June 4, 2017

Re: Comments on Proposed NPDES Permit No. NM0029165  
Village of Ruidoso and Ruidoso Doens WWTP

Re: Comments to Draft TMDL for the Sacramento Mountains

Re: Comments on the August 22, 2016 Public Comment Draft of the  
Nutrient Total Maximum Daily Load in the Rio Ruidoso

Rio Ruidoso at Hollywood Flow  
 Characteristics During Time Period Used  
 for NMED/SWQB Critical Flow  
 Calculations (January 1, 2004 -  
 December 31, 2015)

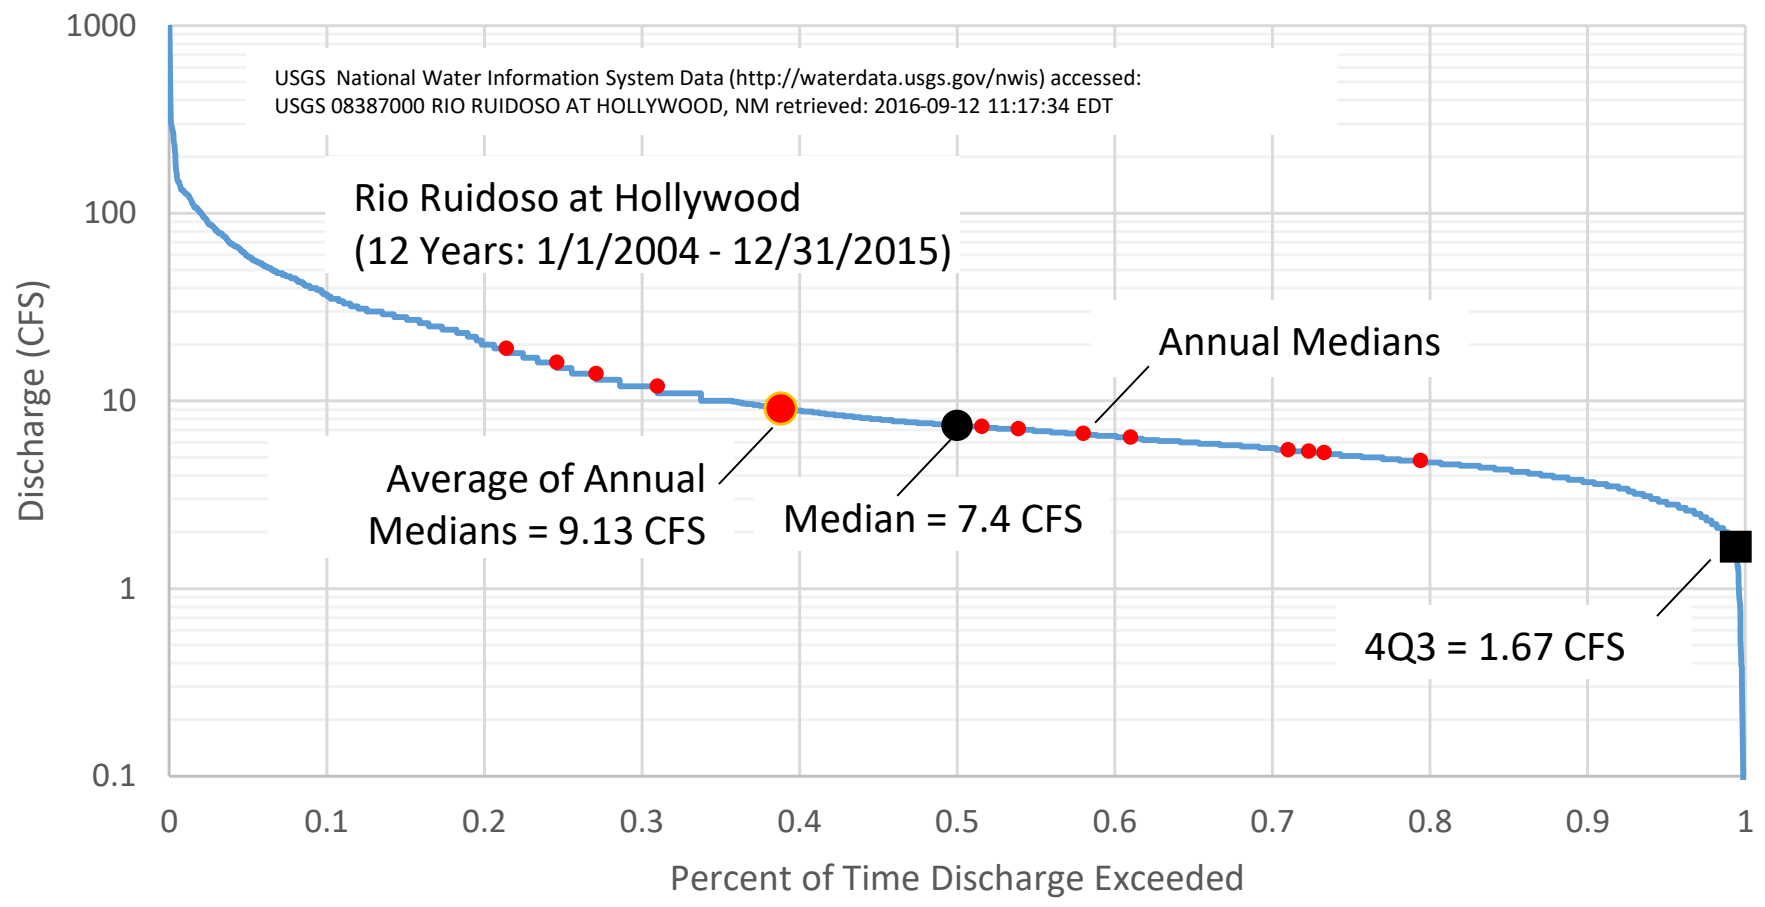
values in the Rio Ruidoso vary quite widely over the course of a year. Over the 2004-2014 period selected by NMED for TMDL planning in this case, the highest monthly median flow was observed in August (10 cfs) and the lowest monthly median flow was observed in June (5 cfs). Looking at the complete period of record, the monthly variability in flows is even more pronounced – from a high of 22 cfs in April to a low of 7.9 cfs in January. The essential point here is that NMED’s choice of an annual median flow as the critical flow for nitrogen overlooks the fact that the Rio Ruidoso is *not* a “steady state” stream. There is high annual variability in monthly precipitation over the course of any given year, and there is also high annual variability in the accrual period over the course of any given year. Any TMDL that does not take this variability into account is arbitrary and capricious.

## Estimate of Flow Loss from Hollywood Gage to Hondo Gage (Two Years of Data)

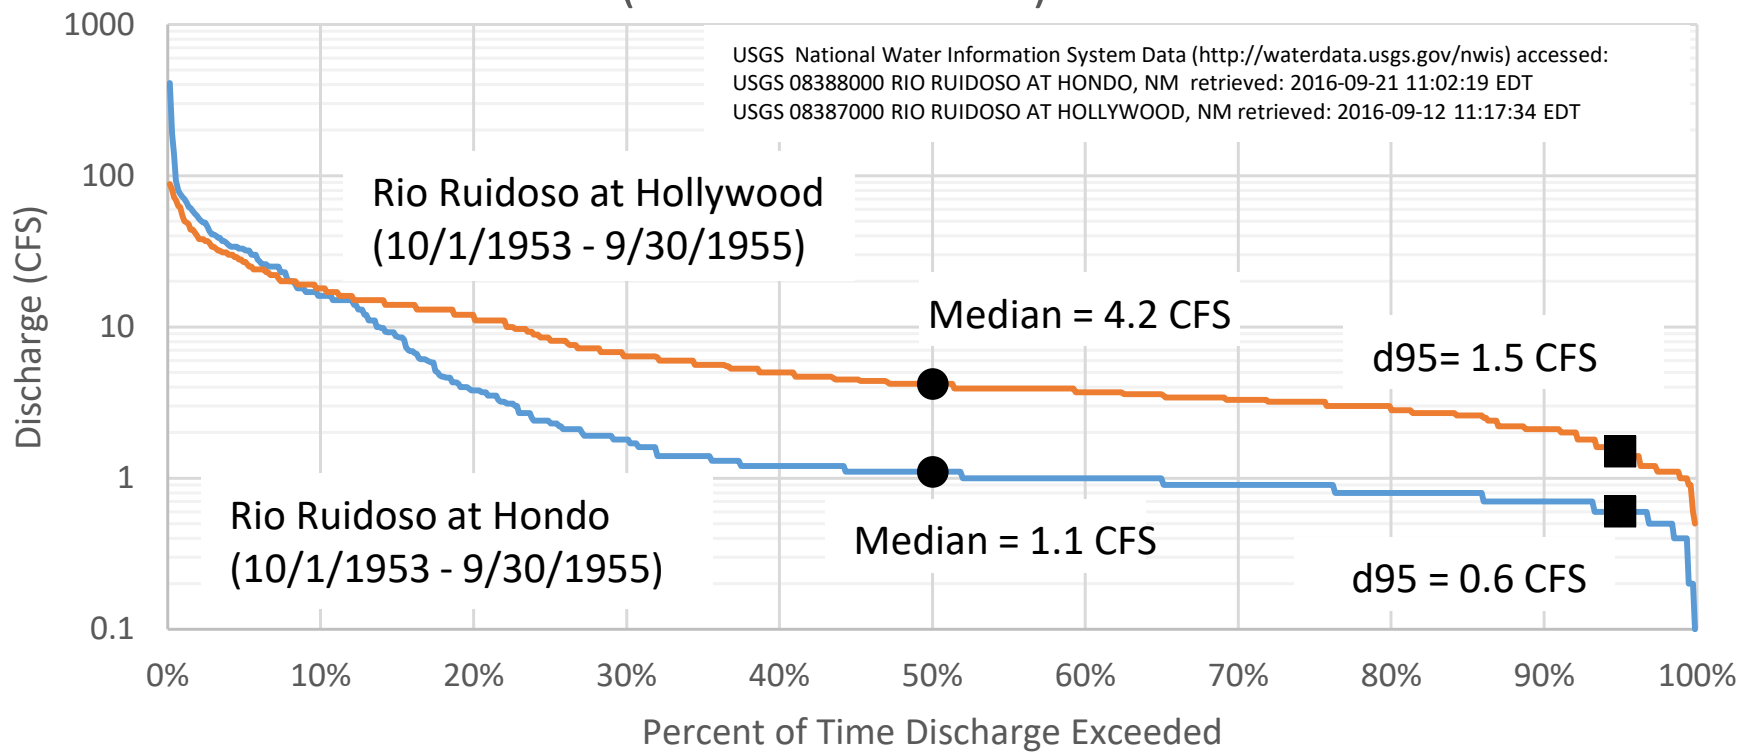
Second, NMED's calculation of the annual median flow for use in development of the nitrogen TMDL for the Rio Ruidoso entirely fails to account for stream flow depletions between the Hollywood gage and the downstream gage in Glencoe towards the bottom of the impaired reach. While NMED used the Thomas equation to extrapolate annual median flows below the wastewater treatment plant from the observed flows at the Hollywood gage – and, in so doing, accounted for the increase in drainage – it entirely failed to consider both the natural and the man-made depletions that occur below the wastewater treatment plant. These depletions are significant, and they cannot be ignored by NMED since the TMDL must be drafted to assure compliance with standards *throughout* an impaired reach, and not just at the *top* of an impaired reach.<sup>6</sup>
